OCWD Comments on: Draft Temescal Basin Groundwater Sustainability Plan, September 2021.

OCWD provided prior comments on the Temescal Basin GSP, Draft Plan Area, Sept. 2020. These comments are presented in Attachment A for completeness.

**OCWD Comments on: Temescal Subbasin Groundwater Sustainability Plan, Draft Plan Area,
September 2020.**

Figure 1. NC Dataset Viewer for PMBZ

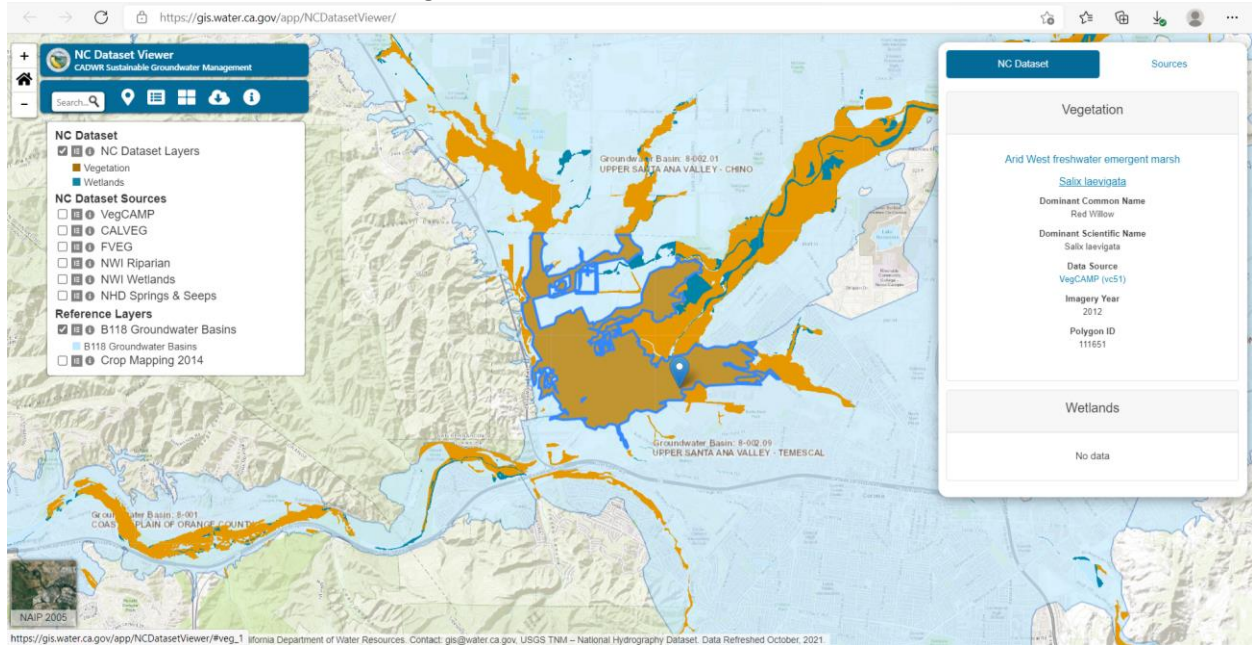
Page 4-17. Section 4.10.3, Riparian Vegetation. This section contains little information about the lower reach of Temescal Creek. This lower reach was very productive until the mid-2000s, when surface flows were reduced. See comments on Section 4.10.1, Stream Flow Measurements and Attachment B for more information on the history of vegetation in the lower reach of Temescal Creek. Section 4.10.3 also needs additional discussion of riparian vegetation in the PBMZ, in the area in and around the Corona Airport. Section 4.10.3 should identify the number of acres of riparian vegetation within the PBMZ (generally speaking the area below ground elevation 566 feet above mean sea level). A key source of data that should be included and shown below (Figure 1) is data from a joint effort of CA DWR and the Nature Conservancy to map areas referred to by DWR as ‘natural communities commonly associated with groundwater ([NC Dataset Viewer \(ca.gov\)](https://gis.water.ca.gov/NCDatasetViewer/)).

Figure 21 Daily Flow in Temescal Creek at Main Street, Corona, CA

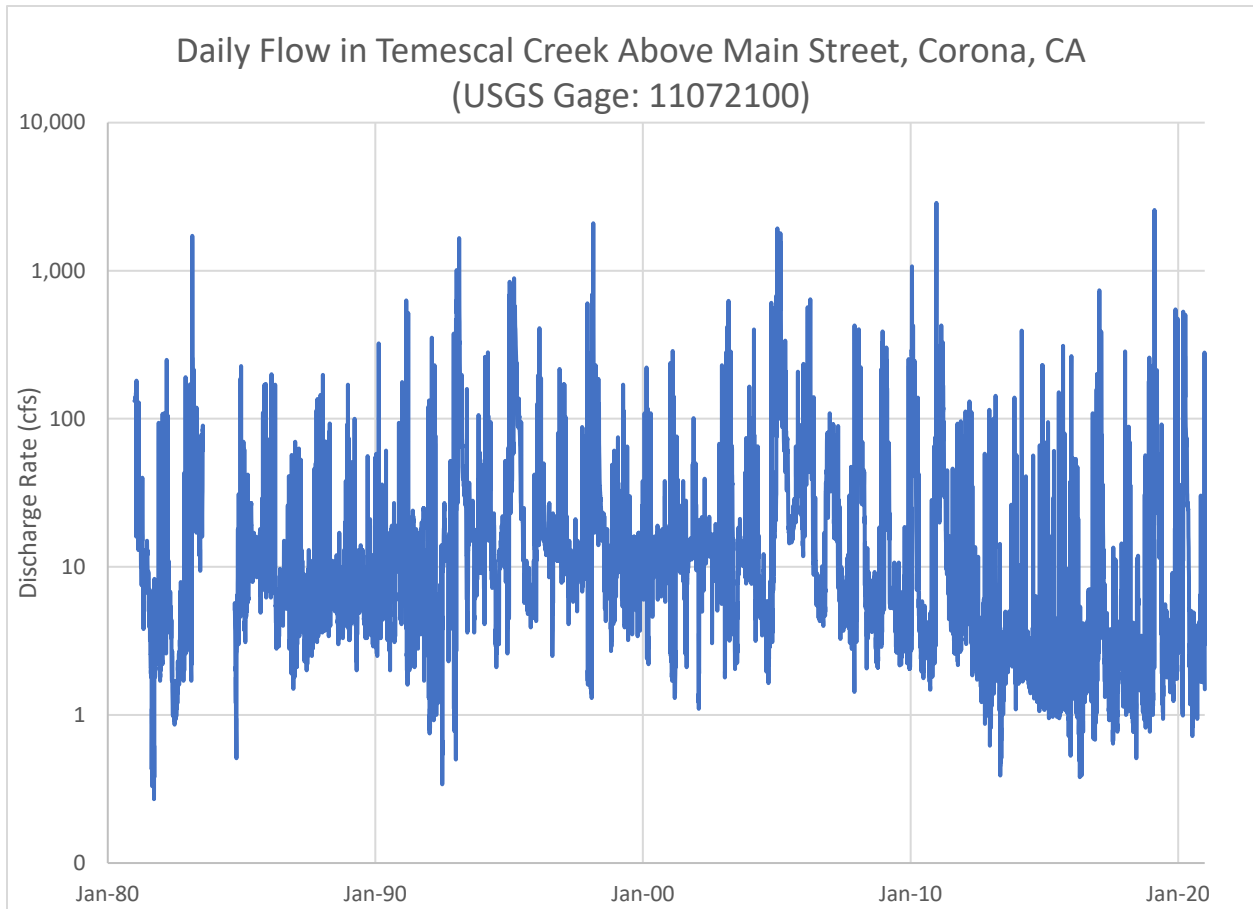
Page 4-15. Section 4.10.1, Stream Flow Measurements. In the discussion of stream flow measurements on Temescal Creek as measured by the USGS gage at Main Street in Corona, CA (Gage No. 11072100), only recent data from 2012 to present is shown (Figure 4-18). In contrast, historical data for the outflow from Prado Dam from 1949 to present is shown. All available historical data from 1980 to present for the Temescal Gage at Main Street is shown in Figure 21 in Attachment B. It is important to note that a noticeable decline in minimum flows is noted in the mid-2000s and has been very low over the past decade. These reductions in flow are due to reduced discharges of treated wastewater and perhaps other factors and has adversely impacted the quantity and quality of riparian habitat in Temescal Creek. OCWD staff biologists reviewed historical aerial photographs and have prepared a summary of the changes noted since 1939, which is presented in Attachment B. This historical summary indicates that the quantity and quality of habitat in the lower reaches of Temescal Creek rapidly declined starting in approximately the mid-2000s. This area remains a good candidate to restore habitat and ecological health provided there was sufficient water supplies.

Figure 21 shows all the available daily measurements of streamflow in Temescal Creek at Main Street in Corona, CA, which is USGS Gage 11072100. What is important to note is the decline in the daily minimum flows that started in the mid-2000s and have been persistently at 1 cfs or less since 2012. These changes in flows correlate with the changes in vegetation described above.
